Lancaster County School District Amendment #1	Solicitation Number	202502	
		Solicitation Issue Date	07/30/24	
		Amendment Issue Date	8/12/24	
		Procurement Officer	Trevor Hammond, NIGP-CPP, CPPB (803) 416-8828	
		E-Mail Address	trevor.hammond@lcsd.k12.sc.us

DESCRIPTION: **Restrooms for BHS & LHS Baseball Fields**

Effective this date, this amendment forms part of the contract documents and modifies the original IFB

WATER & SEWER DETAILS

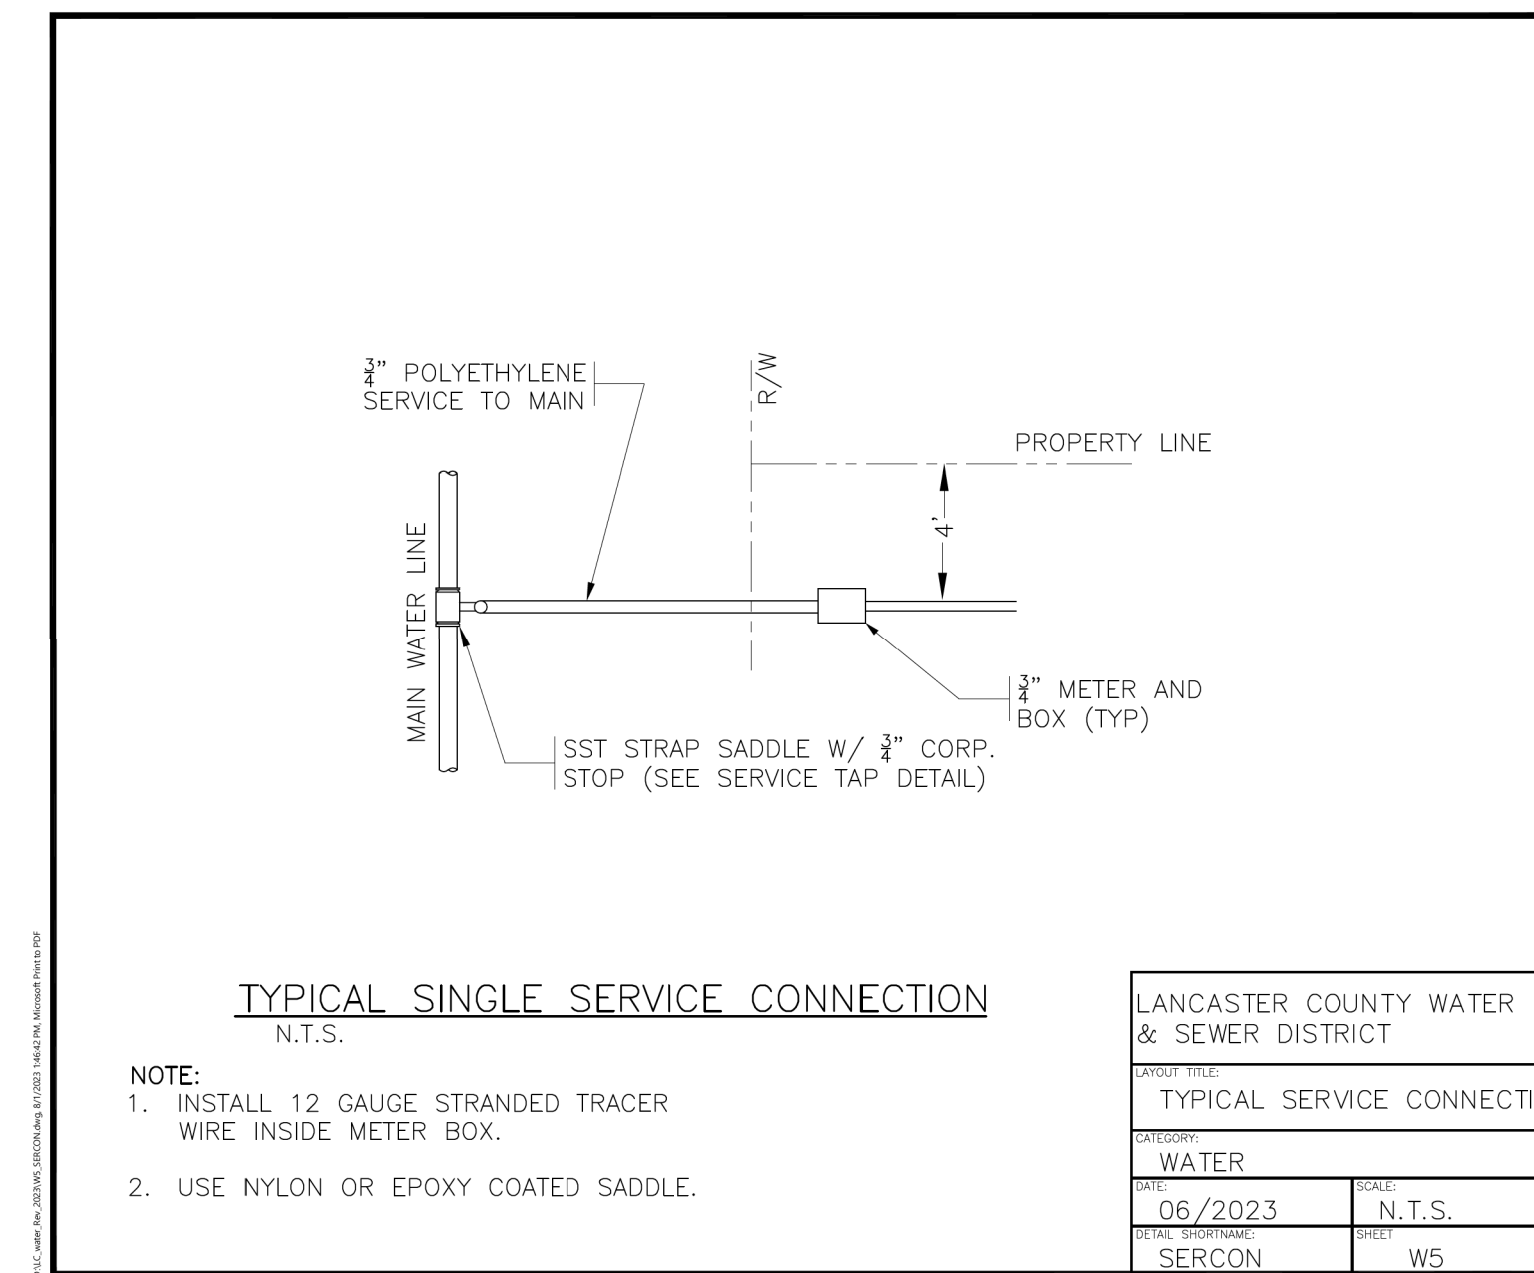
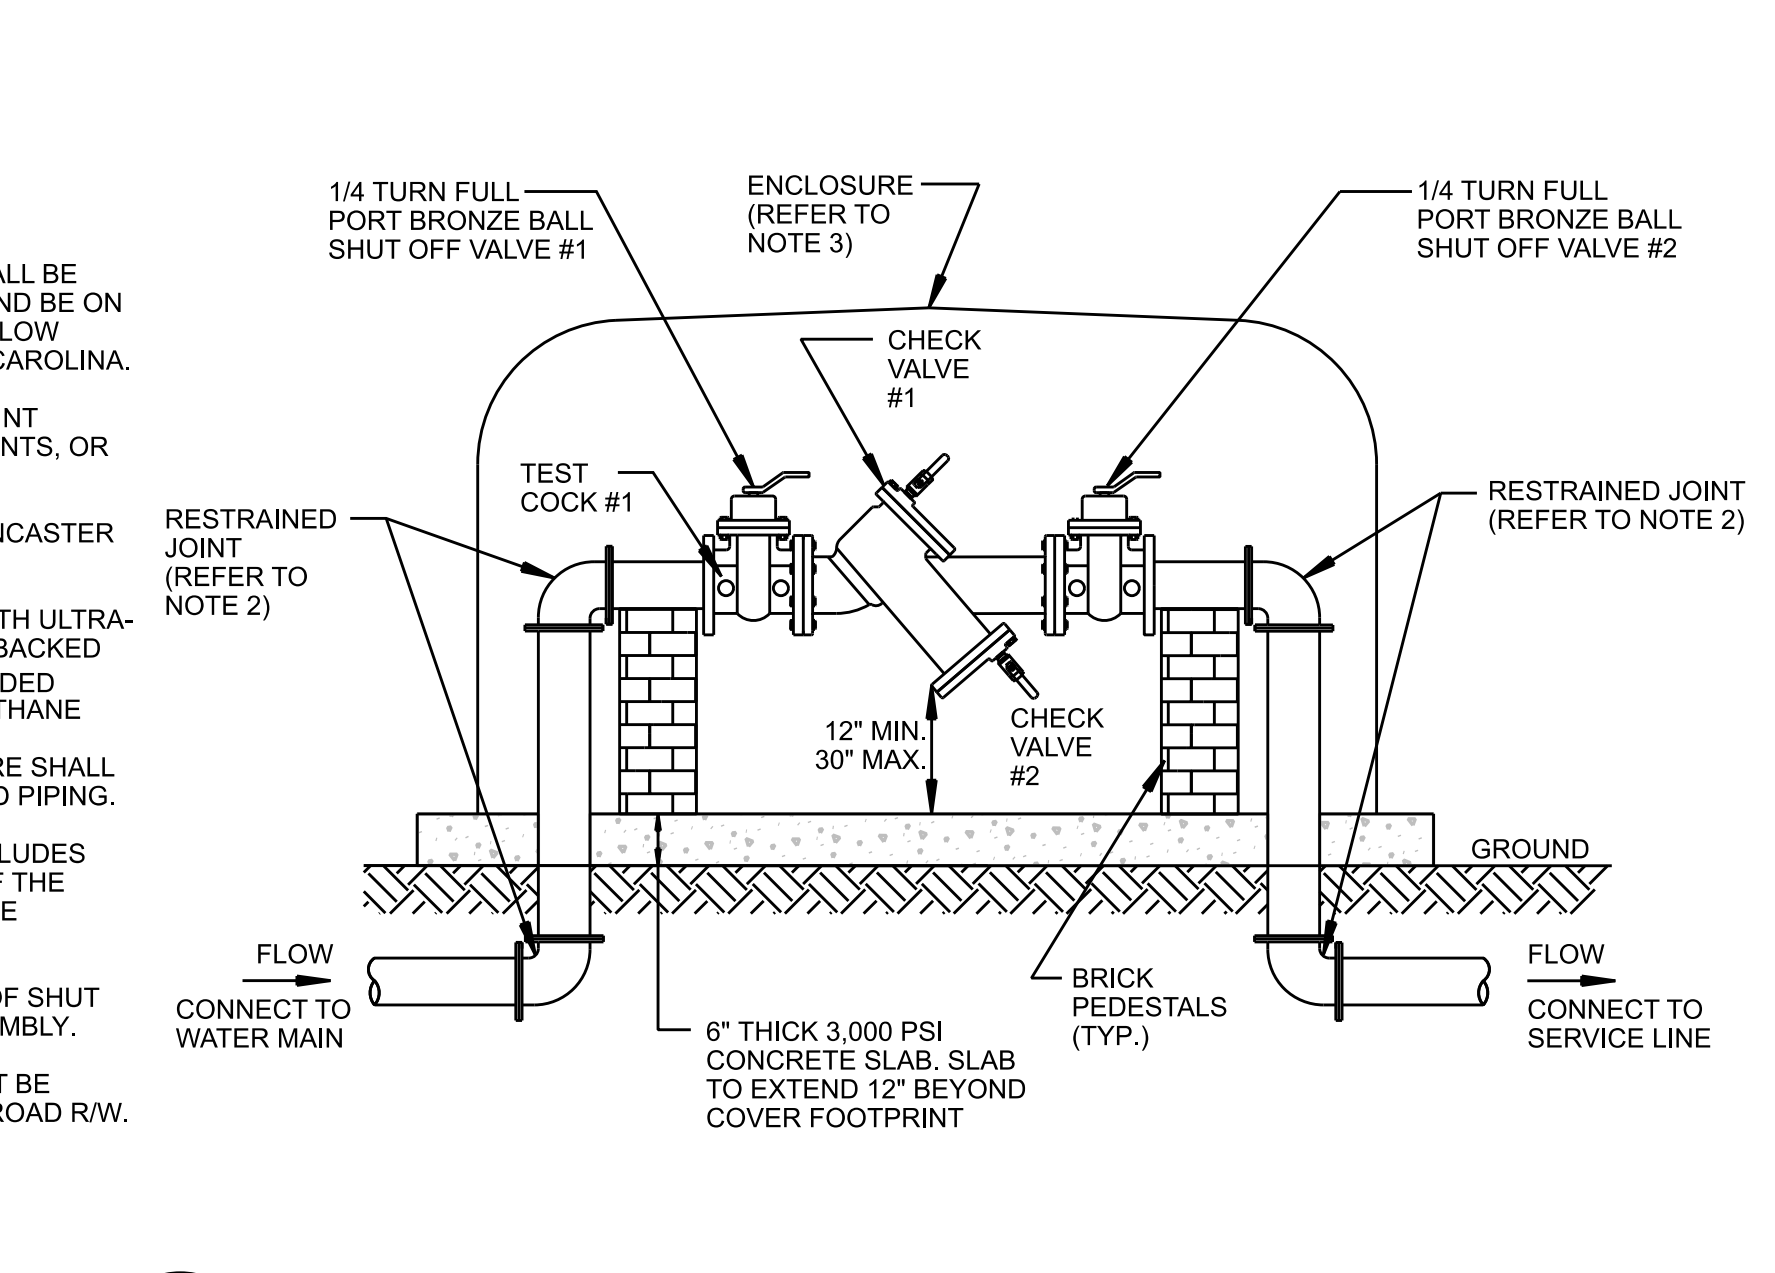
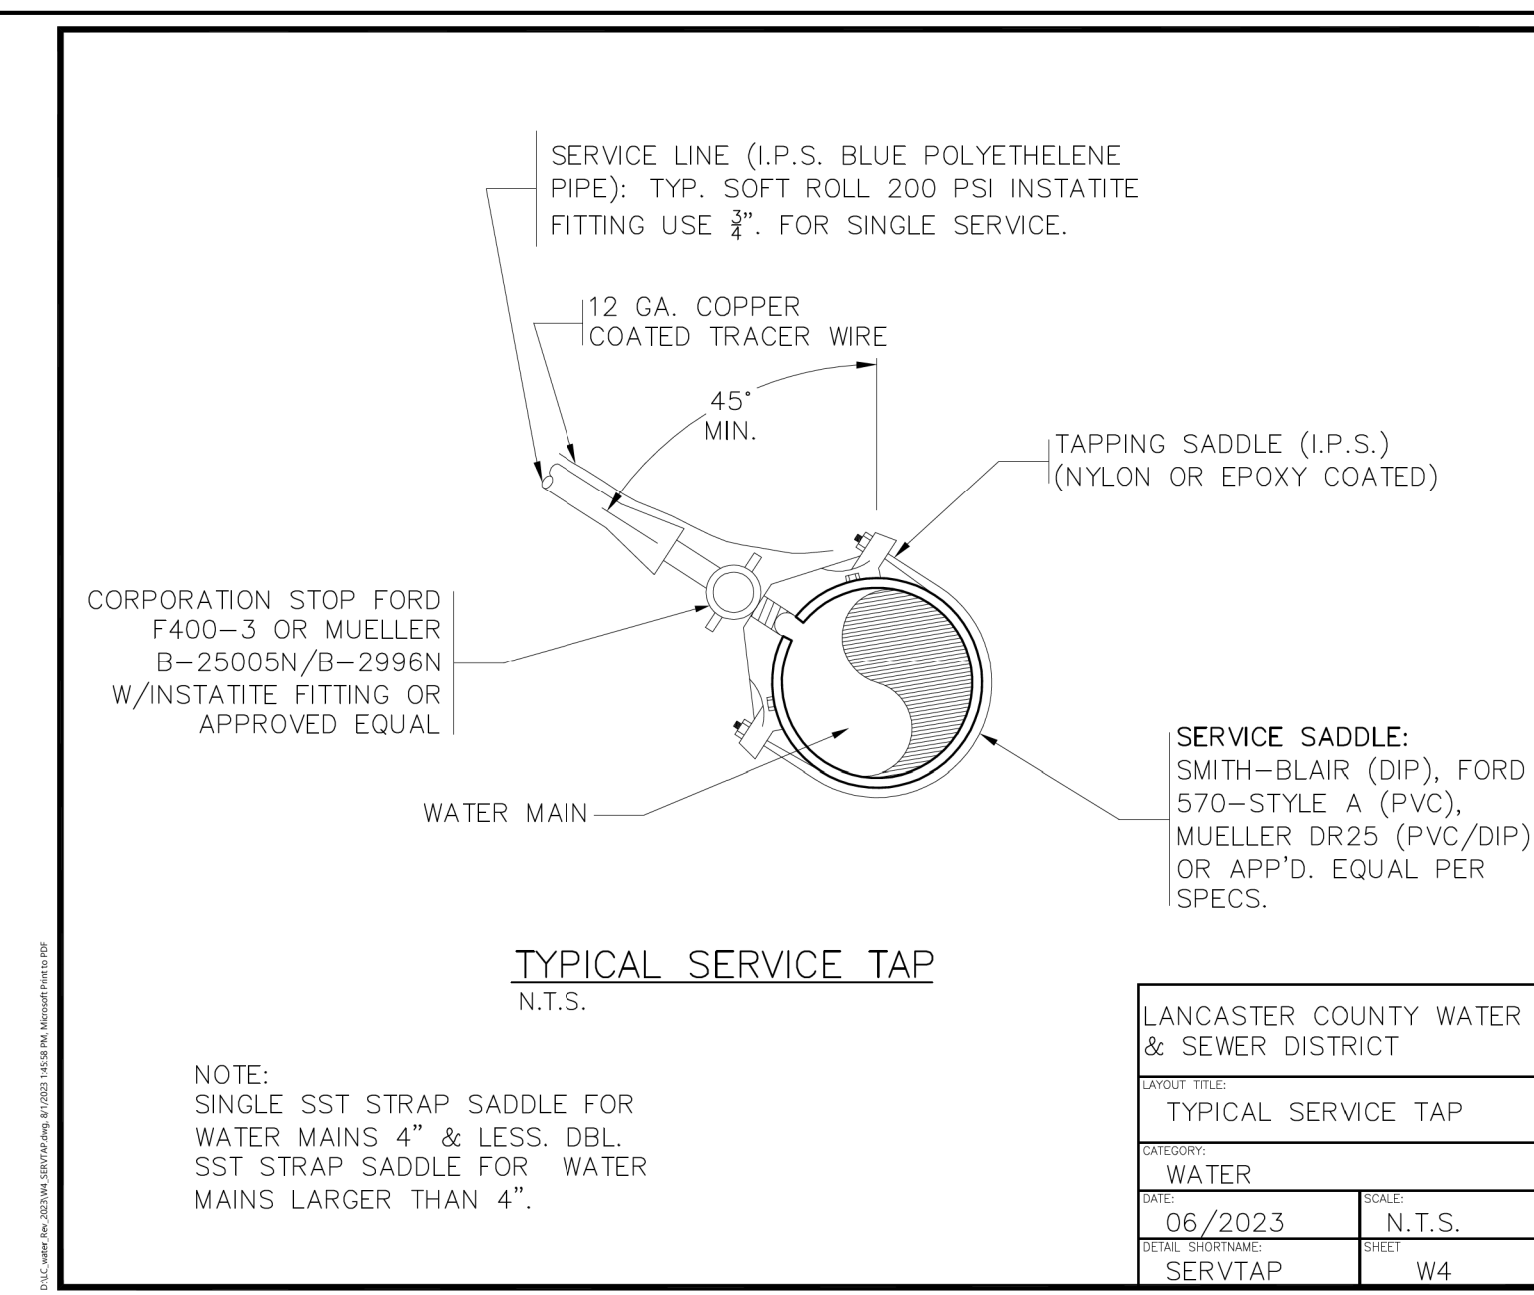
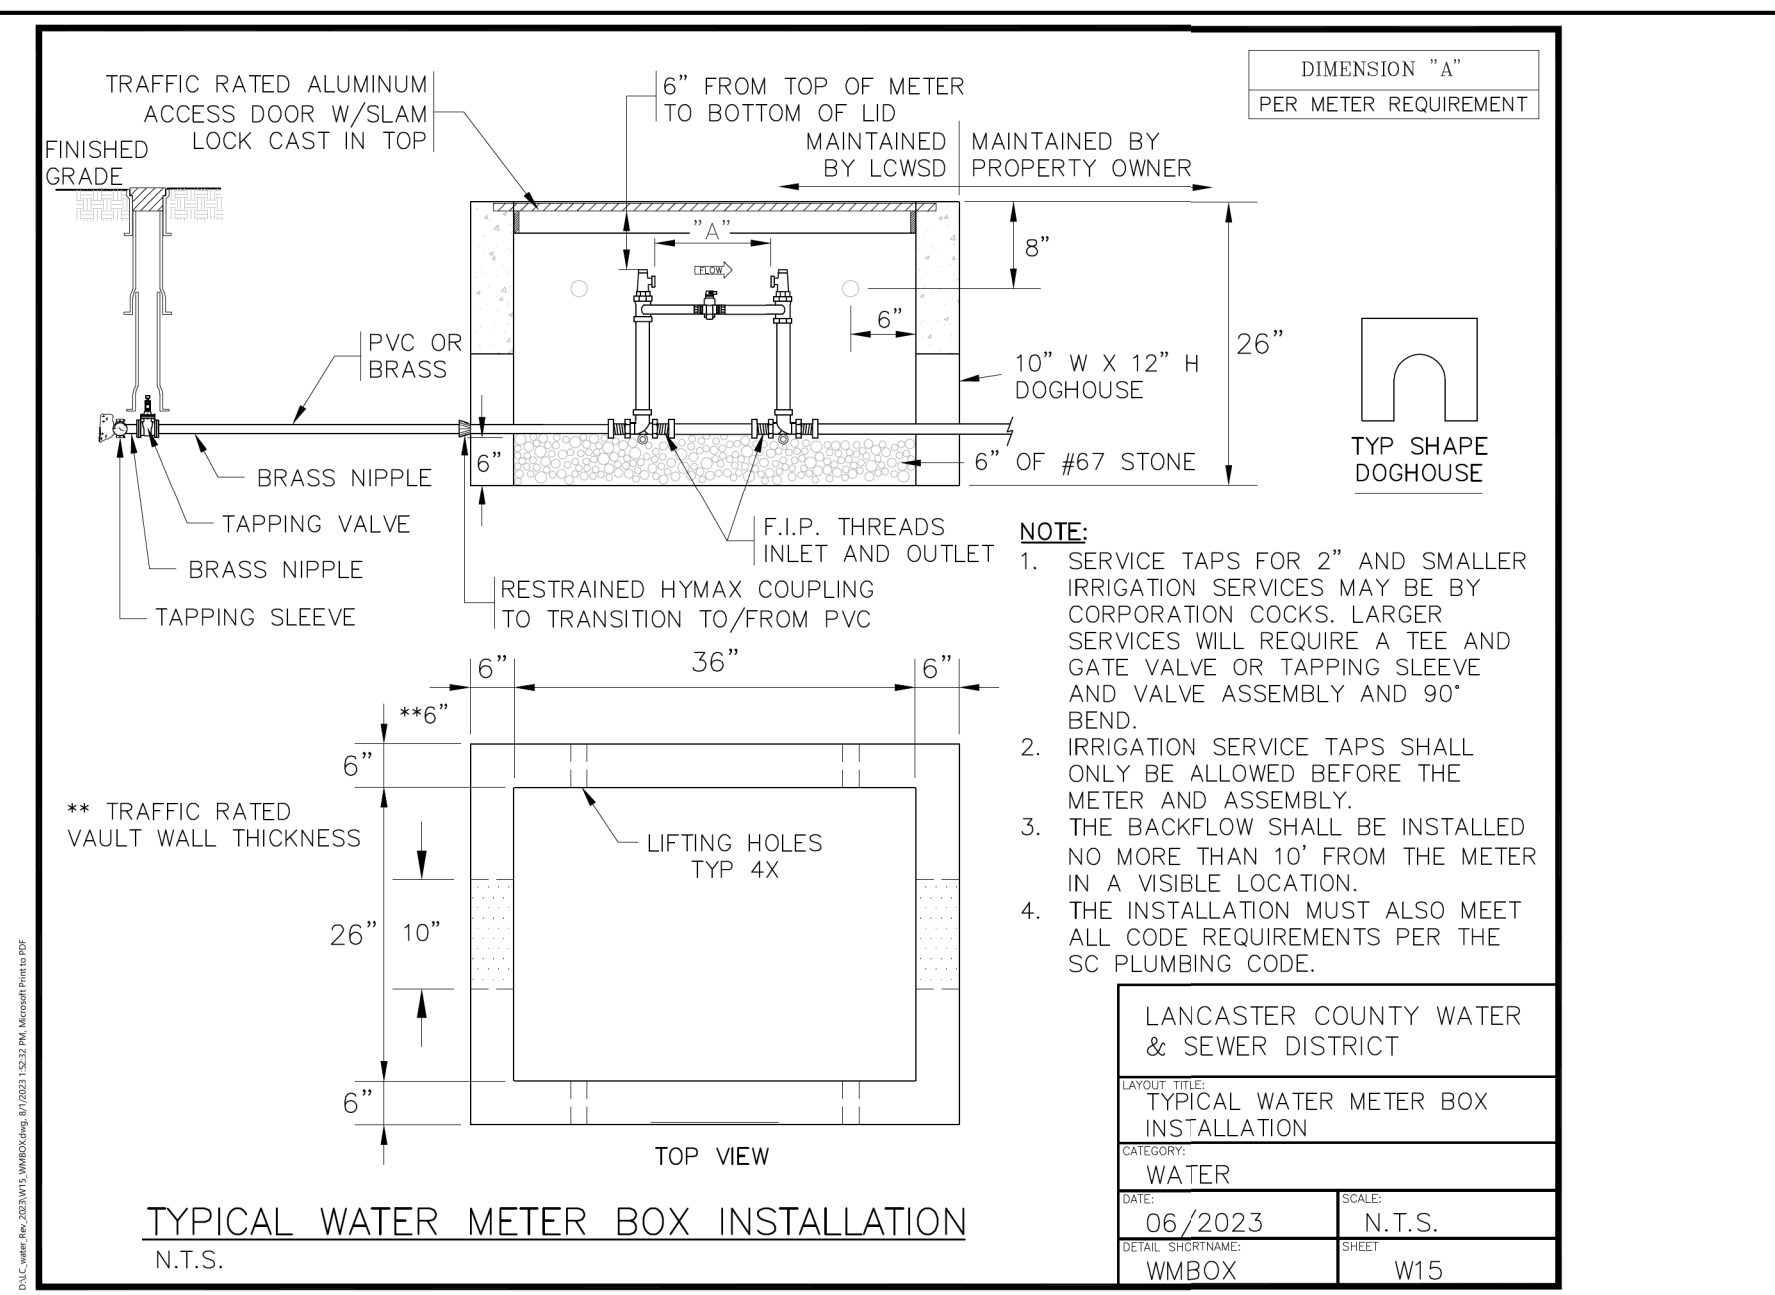
- C. Replace Sheet C501 with revised sheet C501 – Water & Sewer Details, included in the Attachments.
 1. 2-inch polyethylene C-901 water service line has been revised to a 2-inch PVC SDR-21 water service line.

2. 2-inch compression fittings have been revised to 2-inch fittings with blocking.
- D. Replace Sheet A-050 with revised sheet A-050 – Architectural Site Plan, included in the Attachments.
